CITY OF SAINT PAUL HERITAGE PRESERVATION COMMISSION STAFF REPORT

FILE NAME: 1082 Summit Avenue

CLASSIFICATION: Demolition & building permit

Agenda Item IV.D. HPC File# 15-017

1) 1082 SUMMIT GARAGE

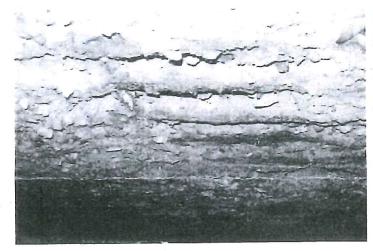
On May 2, 2013 I inspected the above referenced garage floor. The garage is a detached garage with parking at the grade level and a storage room below. (See Picture # 1) The purpose of this inspection was to make a structural evaluation of the concrete floor which supports the parking level.

(3) CORRODED REBAR

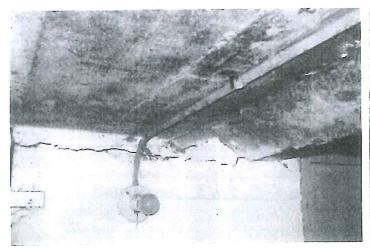
The concrete slab has experienced considerable spalling and deterioration. (See Pictures # 3, 4 & 6) The reinforcing has corroded badly in several locations. (See Picture # 3) The two steel beams have corroded badly also. (See Picture # 4) The steel posts also have extensive corrosion.

Hagstrom Landscape Site Plan

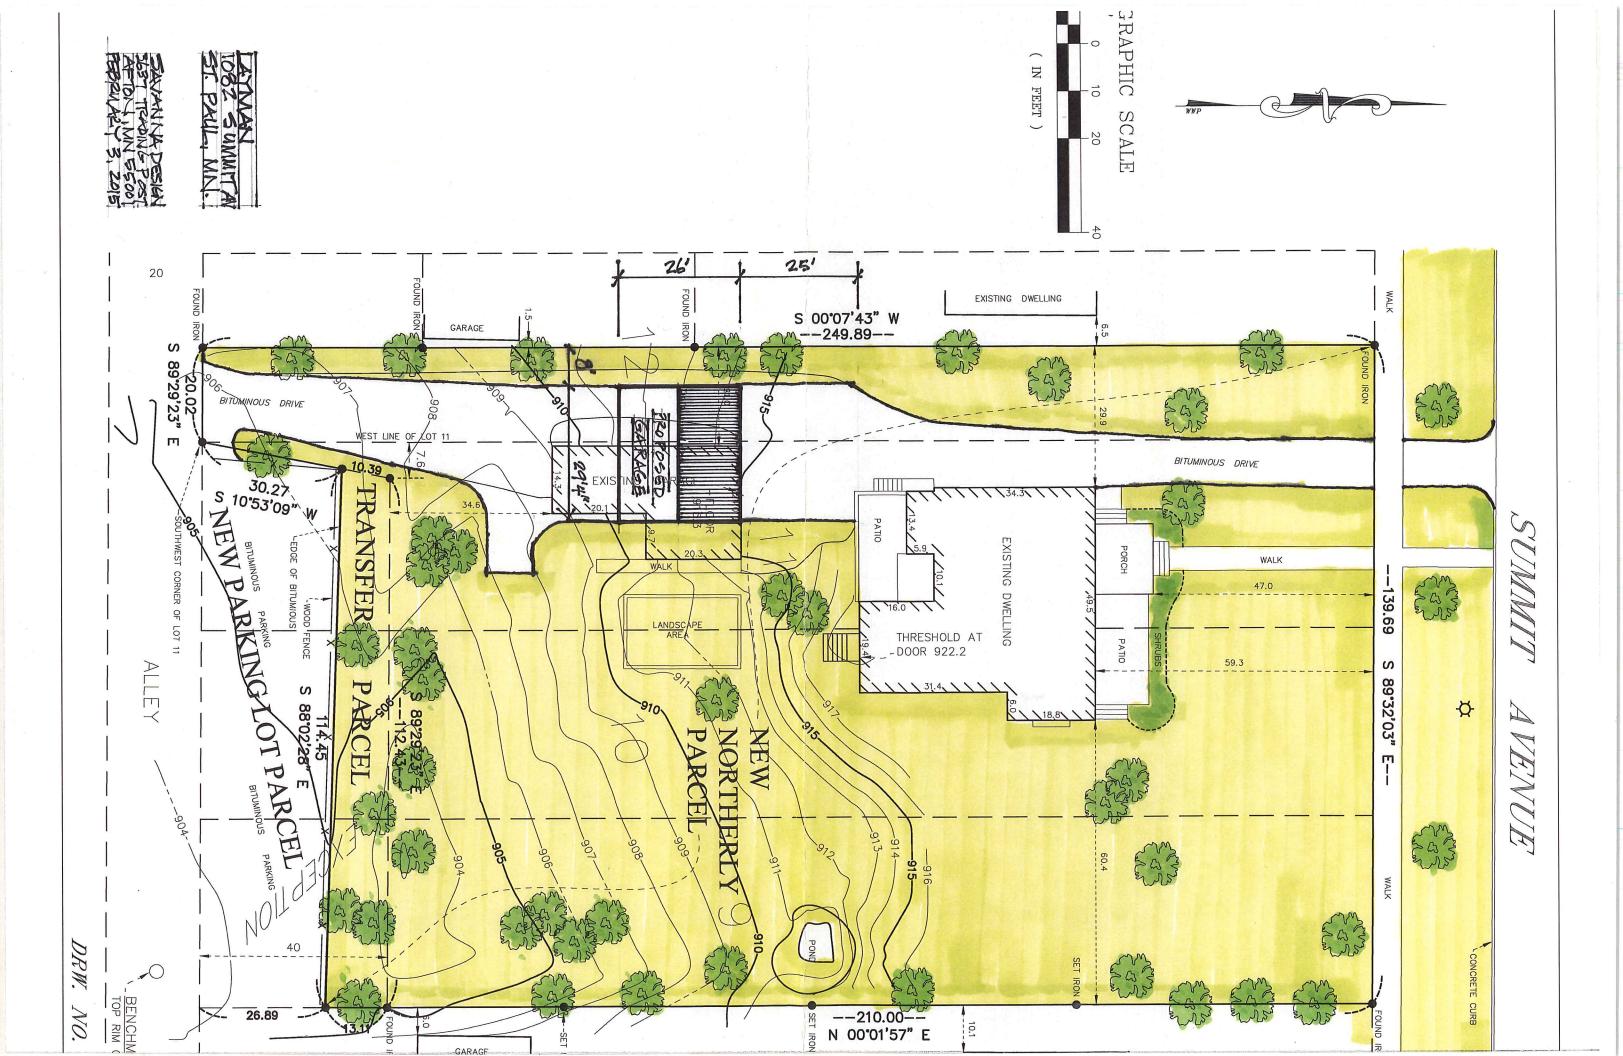
- 10.§74.37(e)(3) The single door garage openings comply with the guidelines. The location of the proposed construction is in the rear yard and close to the rear of the house; its front and rear setbacks are consistent with the historic garage, but it's side yard setback is reduced, thus the garage is more visible from Summit Avenue than the historic garage. If not constructed in the historic location or moved to be setback behind the house, landscape screening should be added to comply with the guideline.

- of the watertable and frieze.
- 3. The garage shall be sited with the same sideyard setback as the original garage or should be constructed mostly behind the house. If not, it shall be screened from the street and sidewalk by landscaping with plans submitted to HPC staff for final review and approval.
- 4. All final materials and details shall be submitted to HPC staff for final review and approval.
- 5. Any revisions to the approved plans must be reviewed and approved by staff and/or the HPC.
- 6. The HPC stamped approved construction drawings remain on site for the duration of the construction project.

FLOORPLANS

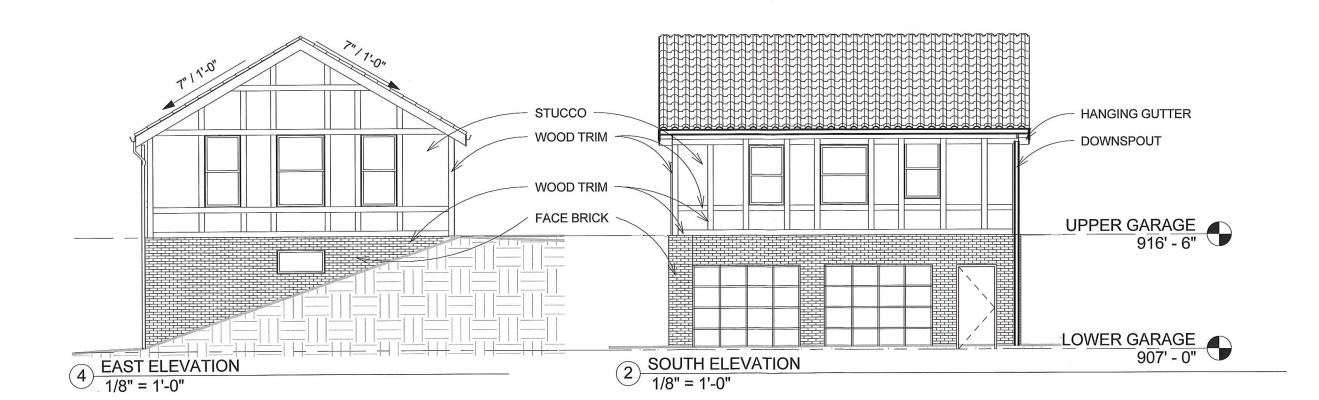
- 7. §74.37(b) The proposed new two story, four-stall garage has a similar footprint to the existing historic garage. The garage volume will increase, but is still clearly and appropriately subordinate to the house.

BUILDING SECTION

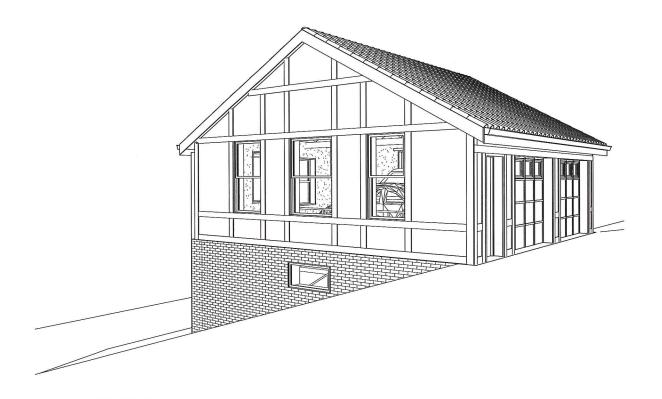
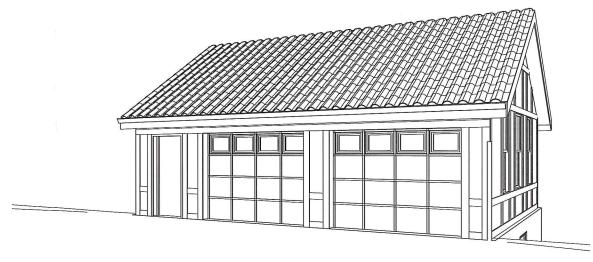
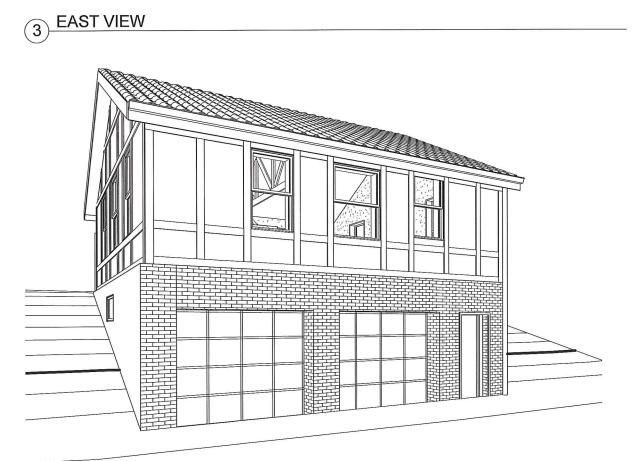
- **8.** §74.37(c) & (d) The proposed materials of the new construction appear to relate to those of the main house. However, the proposed half-timbering is thinner than that found on the historic garage. Façade materials were not provided, but should consist of stucco with wood to comply with the guideline. The roof shape is compatible with the house and original garage with a roof pitch of 7:12.

- 9. §74.37(d)(1) & (2) The side gabled roof shape is compatible with the house and original garage. The proposed roof material is either cedar shingles or stone-coated steel material to match that of the house. The proposed window size and mostly vertical proportions are compatible with the main house, but lack the divided lite detailing found in the historic garage as well as the main house. Service and garage door materials were not provided, but should be of a darker finish to complement the house and details.

- 1. The historic garage shall be documented with photographs prior to demolition. The photos shall be submitted to staff as digital images on a CD and should have a minimum resolution of 300 dpi. Required format is TIFF.
- 2. Window and door specifications shall be submitted to HPC staff for final review and approval. The stucco shall match the color and texture on the house and allow for a profile of the trim and detail. The mock half-timbering on the garage shall relate in profile and size to the detail on the historic garage, specifically, the horizontal elements
